ADDENDUM NO. 1 TO PROJECT NO. 44897

**CONSTRUCTION, HVAC, PLUMBING, ELECTRICAL WORK
ACCESS CONTROL ALTERATIONS & REHABILITATION
CAMP SMITH TRAINING SITE
11 BEAR MOUNTAIN ROAD
CORTLANDT MANOR, NY 10567**

August 6, 2015

1 COMMAND & CONTROL DOOR SWING
 SKC-01 1/4" = 1'-0"

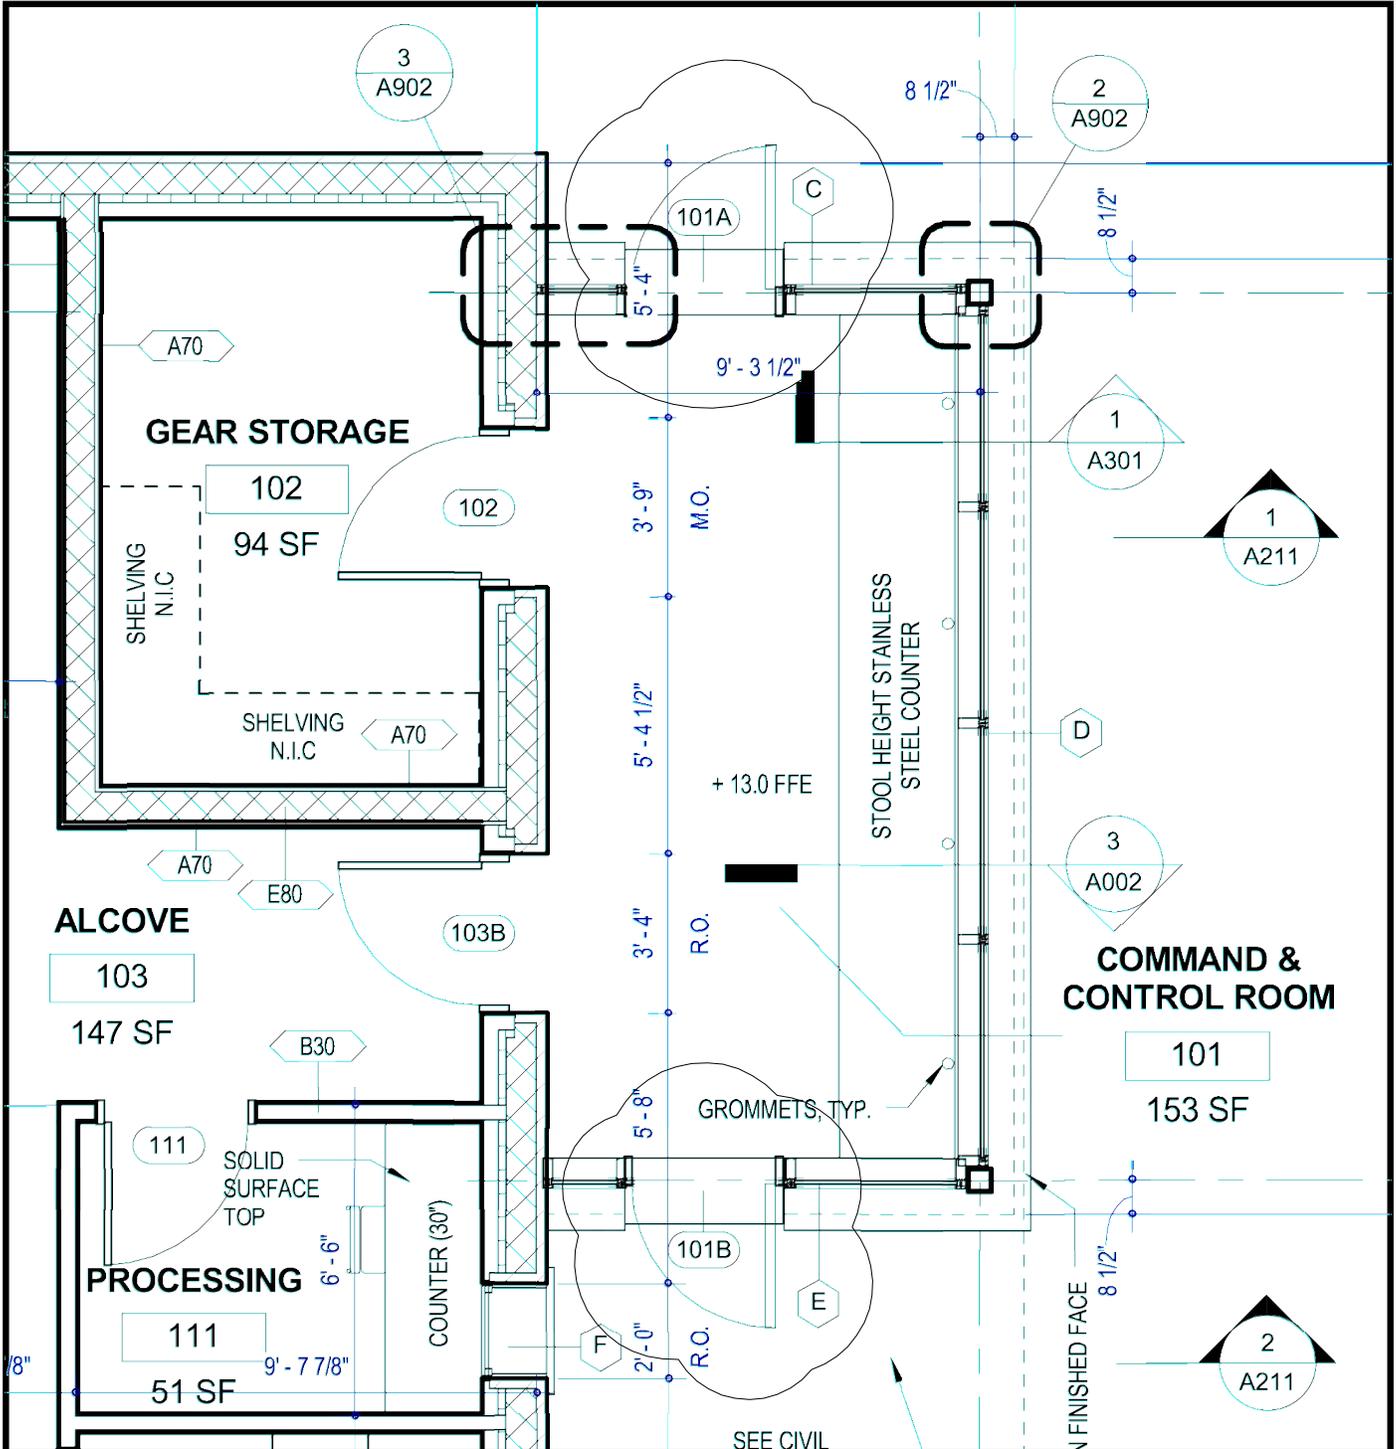
- a. The size of the gutter, typical, is 6”.
8. Drawing No. A-101:
 - a. Doors 101A & 101B in the Command and Control Room have been flipped as shown on the attached Door Change Sketch. SKC-01.

1	SCHEMATIC CABINET ELEVATION
SKC-02	1/2" = 1'-0"

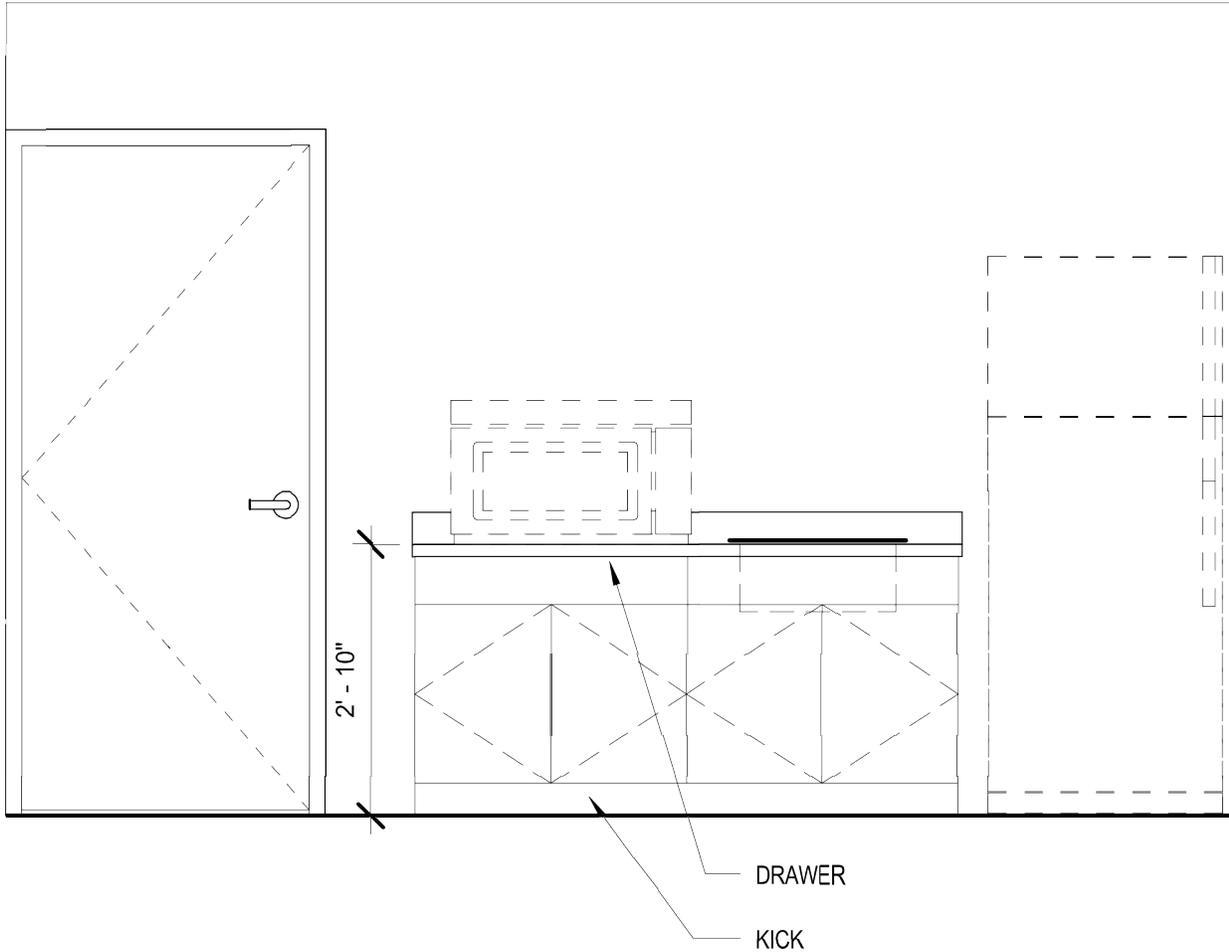
- b. Surface treatment inside the center canopy island shall be concrete walk per details on drawing C-501.
11. Refer at attached addendum sketch SKC-02, which modifies drawing A-102

2	SNOW MELTING DETAIL – HEAT TRACE
-	NOT TO SCALE

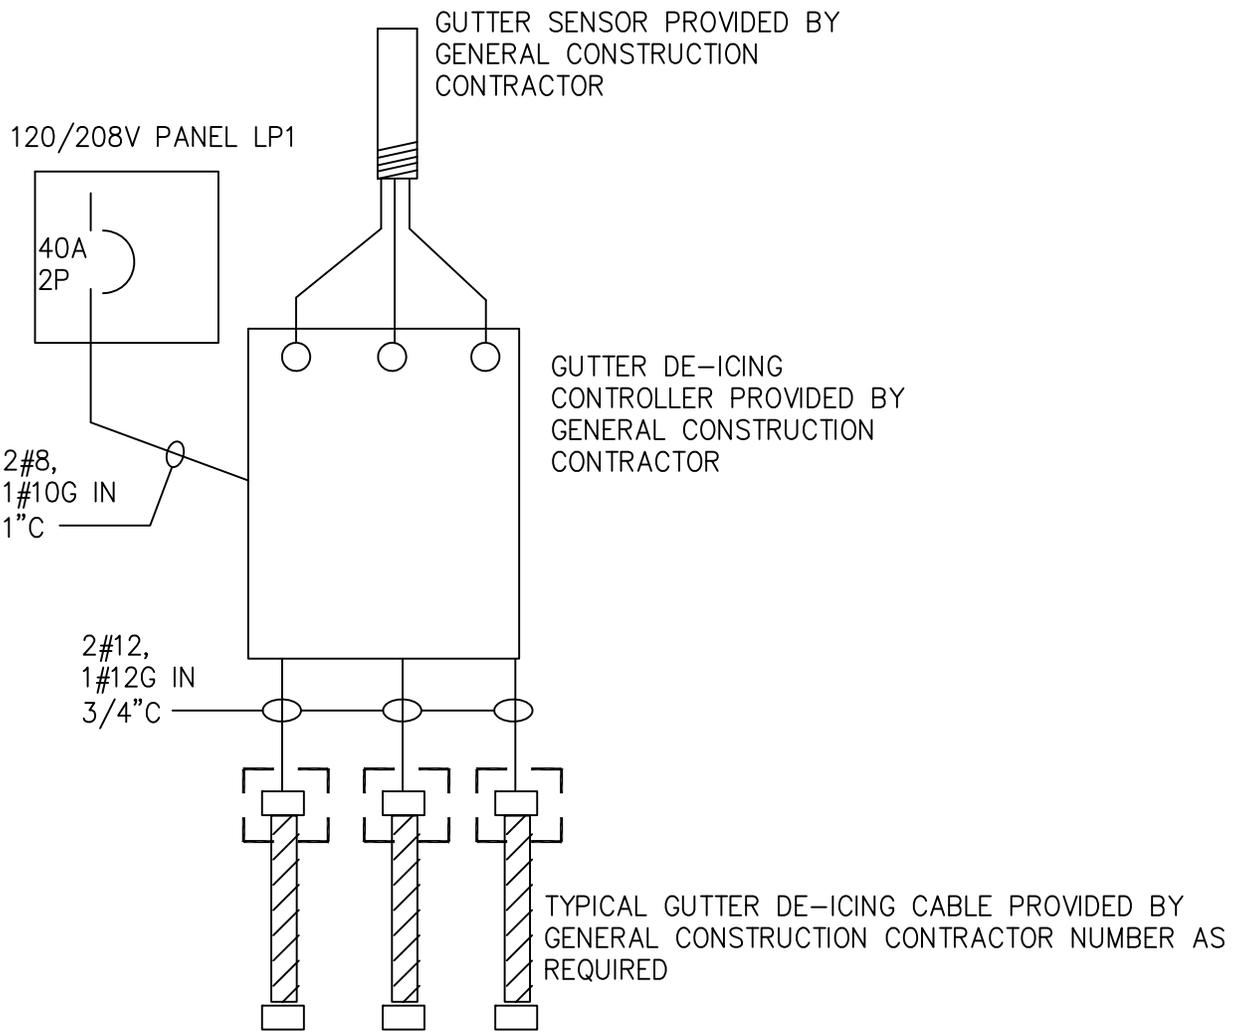
13. Drawing E-103:
 - a. Revise Coded Note 6 to read as follows: “Gutter De-icing system to be provided by General Construction contractor. Provide electrical connections from gutter de-icing controller located in the electrical room to each gutter de-icing run provided by the general contractor. Coordinate with General Construction contractor for power wiring requirements and location of terminations between gutter de-icing self-regulating cable and building power wiring. Electrical contractor to provide branch circuit conduit and wiring between building power panel “LP1” and gutter de-icing controller and conduit and wiring between gutter de-icing controller and gutter de-icing self-regulating cable within each gutter. Refer to A-103 for gutter locations.”
14. Refer at attached addendum sketch SKE-01, which modifies drawing E-504.

1. COORDINATE WITH GENERAL CONSTRUCTION CONTRACTOR FOR ELECTRICAL POWER ROUGH-IN REQUIREMENTS PRIOR TO FINAL BUILDING FRAMING.
